ADDENDUM NO. 1

DATE: October 23, 2018
FROM: Village of Villa Park Public Works Department
TO: All Planholders
PROJECT: **Jackson Pond Overflow**

JACKSON POND OVERFLOW PROJECT

LAYOUT PLAN — AREA 2

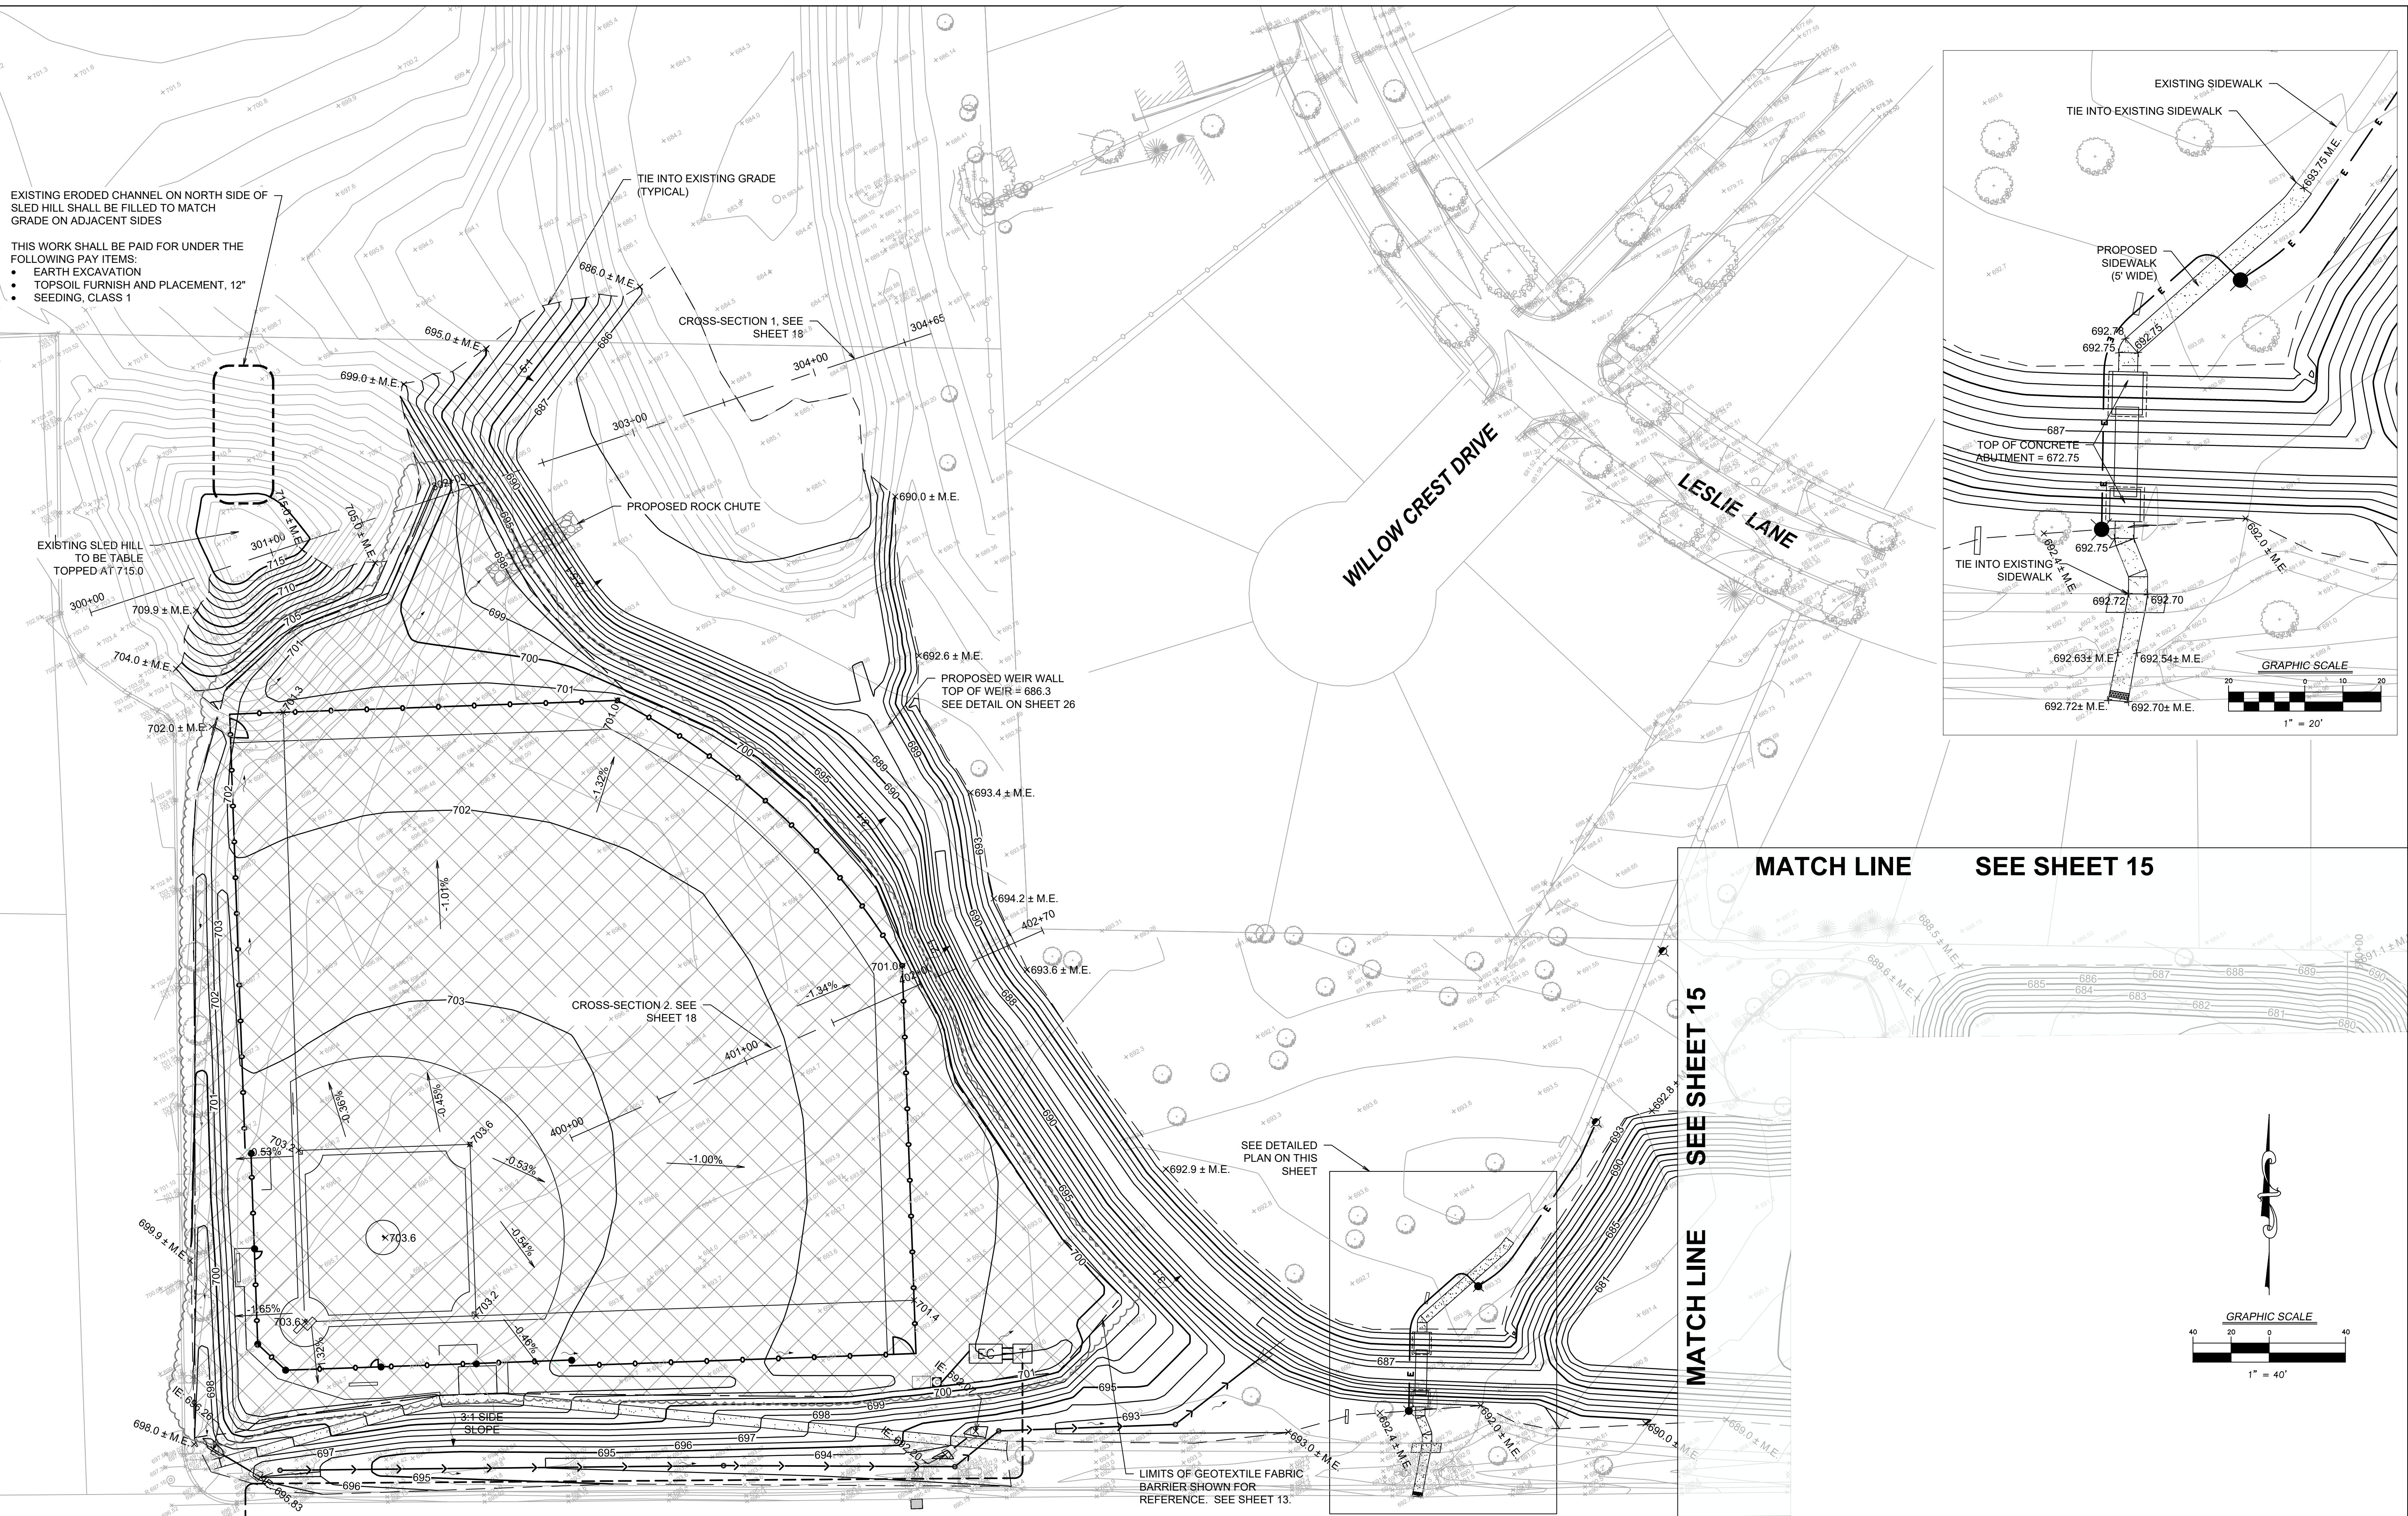
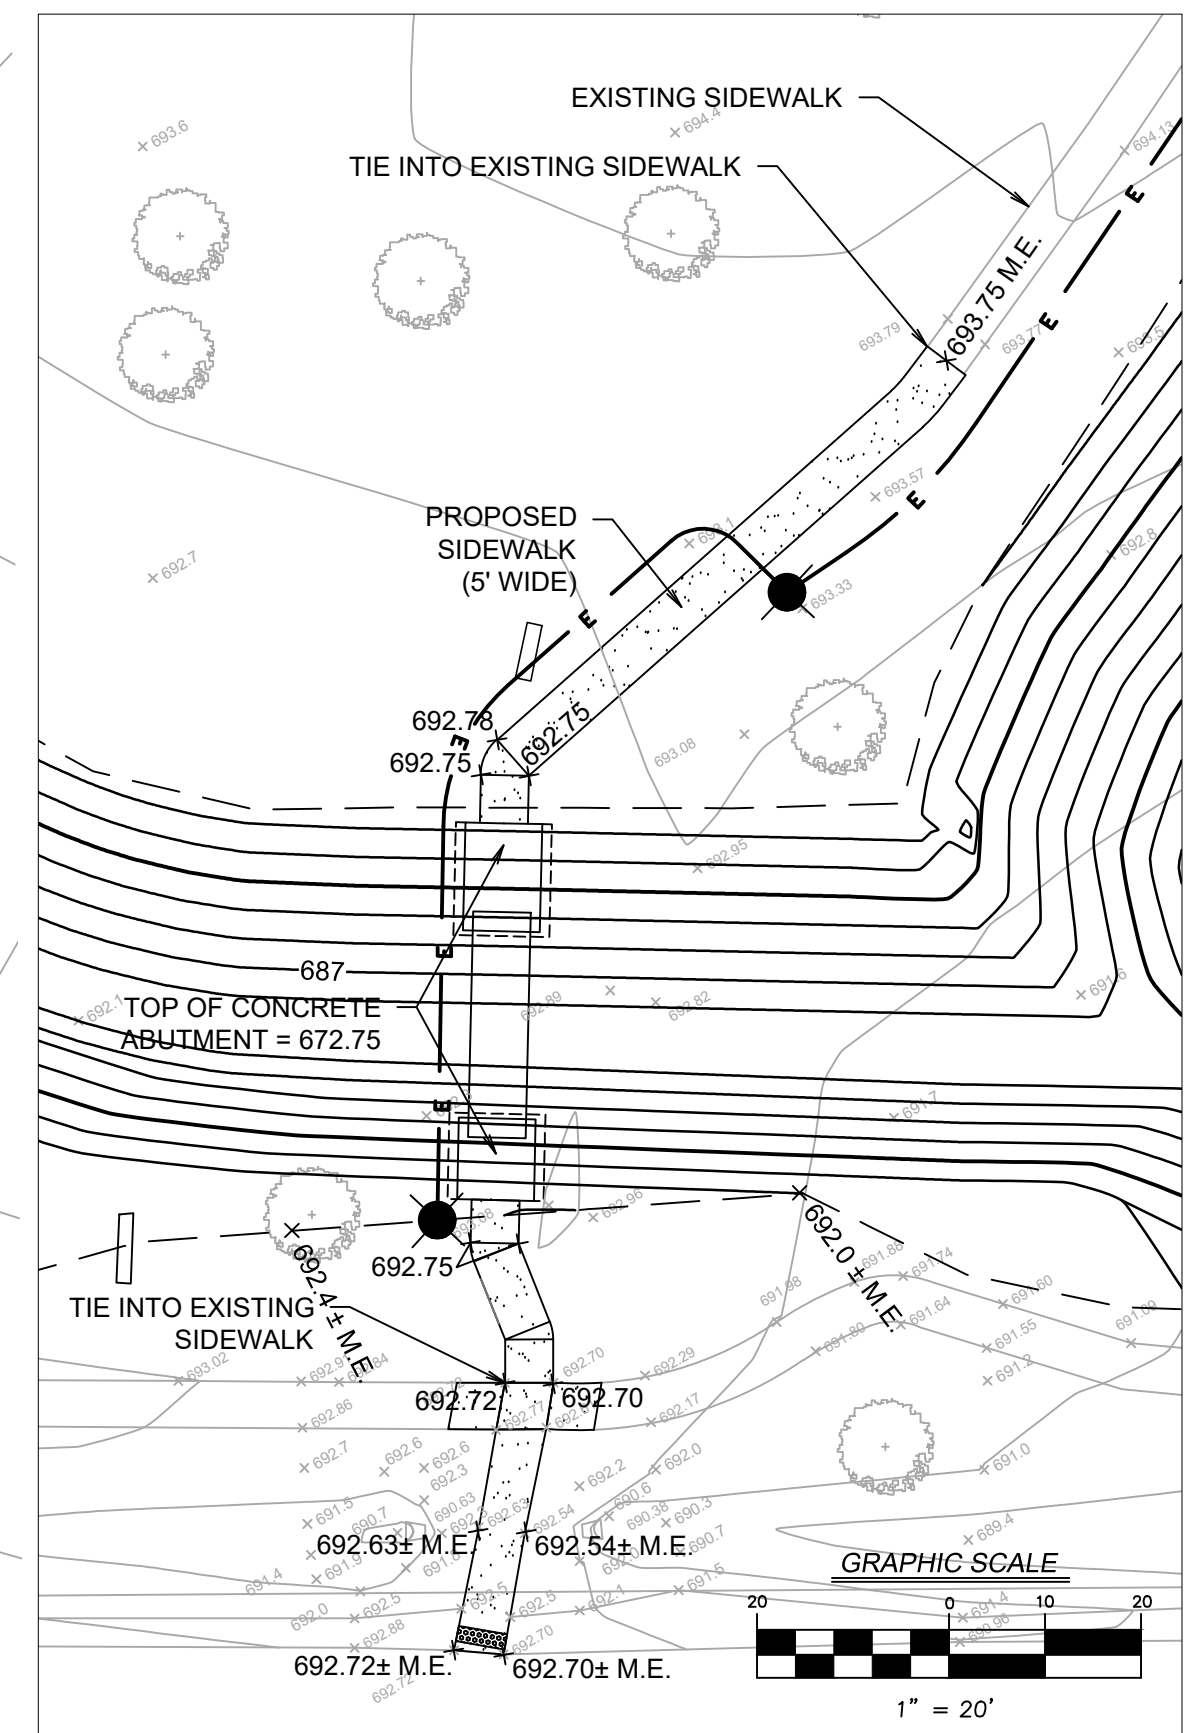
Replace Pages 13 and 16 of the Plans with the attachment included in this addendum. The revision made was the addition of the GEOTEXTILE FABRIC BARRIER. The revisions are bubbled on the plan sheet.
